PROJECT: CASTRO COUNTY JAIL
1004 E. BEDFORD STREET
DIMMITT, TEXAS 79027

DATE ISSUED: DECEMBER 1, 2017

ADDENDUM NO. 1

ATTACHMENT
NUMBER

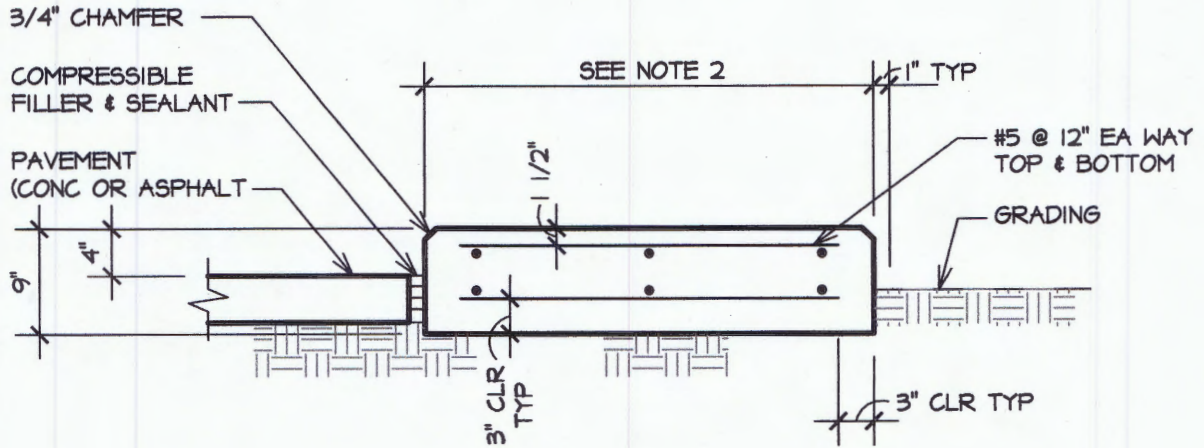
- A. At the Locker Schedule, add personal property lockers in Vestibule 002, as indicated on Attachment No. 1.

ROOM NUMBER	LOCKER TYPE	LOCKER SIZE WxDxH INCHES	NUMBER OF LOCKERS IN COLUMN	LOCK TYPE	REMARKS
ADMINISTRATION AREA					
Staff Lockers in Corridor 023	Staff	12x15x36	2	Handle w/Padlock Hole	22 Lockers Total
Corridor 023 to Evidence Processing 025	Evidence	1-T-12x18x12 1-T-12x18x18 1-T-12x18x72	6 4 1	Key	11 Lockers
Personal Property Lockers In Vestibule 002	Personal Property	3-T-12x12x66	5	Key	15 Lockers
